Summary of Data Quality Objectives
Ranges near Training Area T-24A, Parcels 187(7), 112Q, 113Q-X, 213Q, and 214Q
Fort McClellan, Calhoun County, Alabama

RESPONSE TO COMMENTS

**SITE-SPECIFIC SAMPLING AND ANALYSIS PLAN AND
SITE-SPECIFIC SAFETY AND HEALTH PLAN ATTACHMENTS
AT THE RANGES NEAR TRAINING AREA T-24,
PARCELS 187(7), 112Q, 113Q-X, 213Q, AND 214Q
FORT MCCLELLAN, ALABAMA
RESPONSE TO COMMENTS BY ADEM**

Figure 3-1
Human Health Conceptual Site Exposure Model
Ranges Near Training Area T-24A, Parcels 187(7), 112Q, 113Q-X, 213Q, and 214Q
Fort McClellan, Alabama

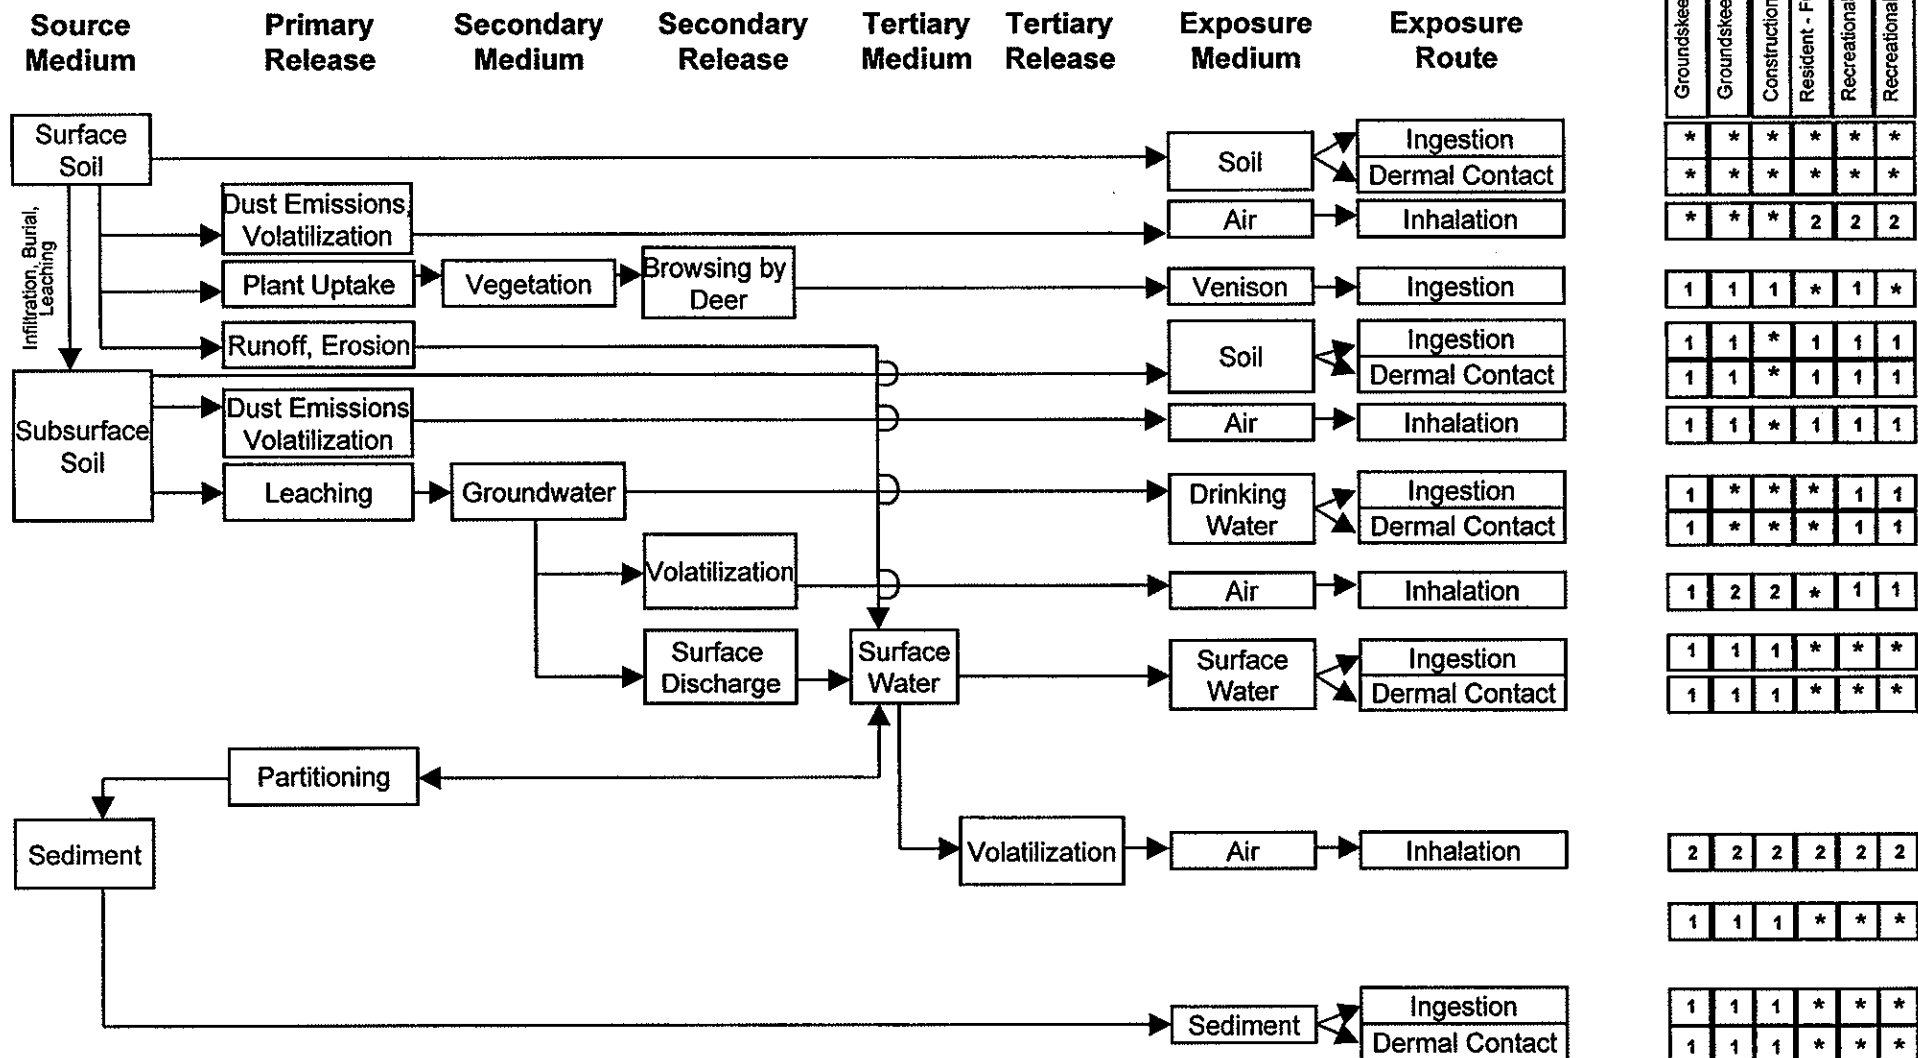
Comment 2: **A minimum of three sediment and surface water samples should be collected from the creek segment within parcel 113Q-X which is between Training area T-24A and Parcel 213Q. These samples are needed because of the relatively close proximity of the creek to the former burning pits and the creek segment is within the former demolition area. The groundwater flow direction and the topographic relief indicate the possibility of contaminant migration pathways from the T-24A area to the creek. Also the creek is downhill from Parcel 213Q. No sediment or surface water samples are currently proposed. It does not appear from Figure 2-1, 2-2, and 4-1 as if sediment and surface water samples were**

Response: The criteria of three sediment/surface water samples for this RI event will be satisfied for the surface water feature present at this location. Appropriate QA/QC samples will be collected as necessary. Figures 3-1 and 4-1 and Tables 3-1, 4-1, 4-4 and 4-5 will be updated with these samples.

FIGURE 4-1
SAMPLE LOCATION MAP
RANGES NEAR TRAINING AREA T-24A
PARCELS 187(7), 112Q, 113Q-X, 213Q
AND 214Q

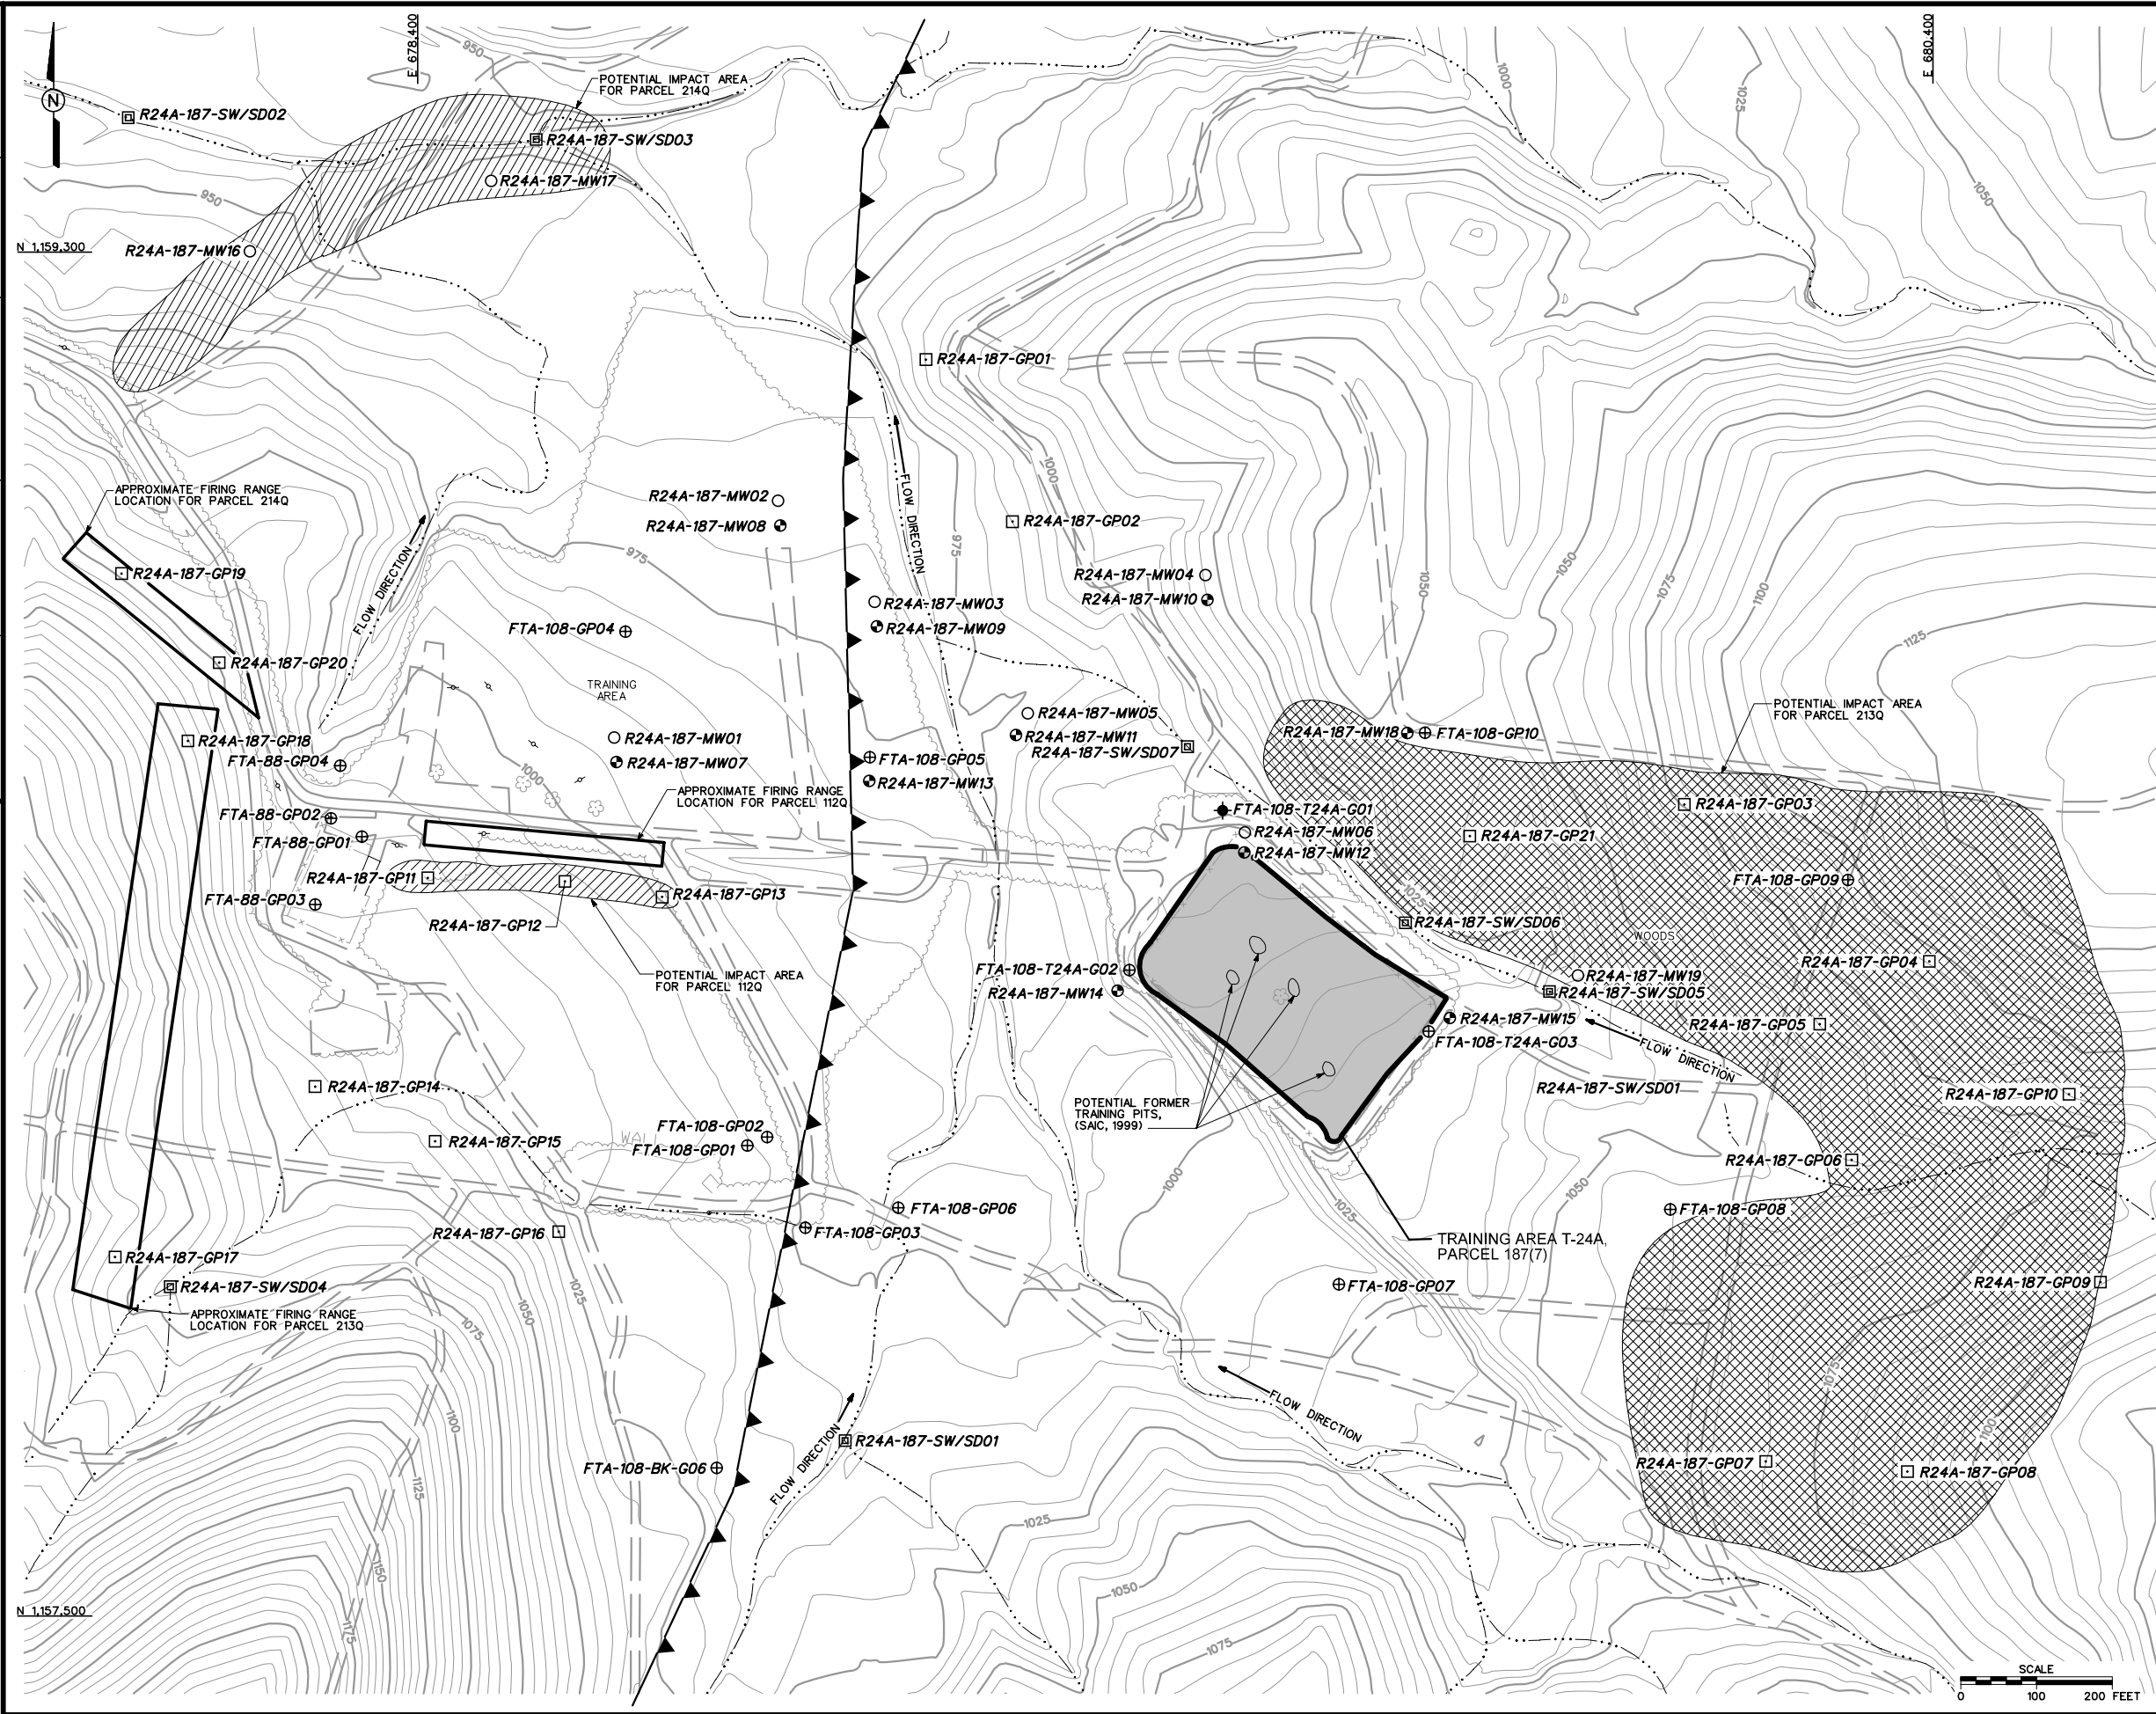
Comment 19: **Page 4-2/Section 4.2.1.1/Lines 23-26: Apparently this Supplemental Remedial Investigation did not propose any sample locations within the boundaries of Training Area T-24 (see Figure 4-1). There were soil and groundwater samples taken around the perimeter of Training Area T-24 but not within T-24's boundaries. At least two surface soil samples, one subsurface soil sample, and one groundwater sample need to be taken within the boundaries of the Training Area T-24.**

Response: Training Area T-24 is a CWM concern that will be addressed by Parsons Engineering as part of the CWM EE/CA (*Work Plan/Site Safety Submission, Volume 1 – Work Plan, Chemical Warfare Materiel Site EE/CA*, March 1999). Based on the conclusions of the EE/CA for T-24A, HTRW investigative activities may be completed, if warranted.
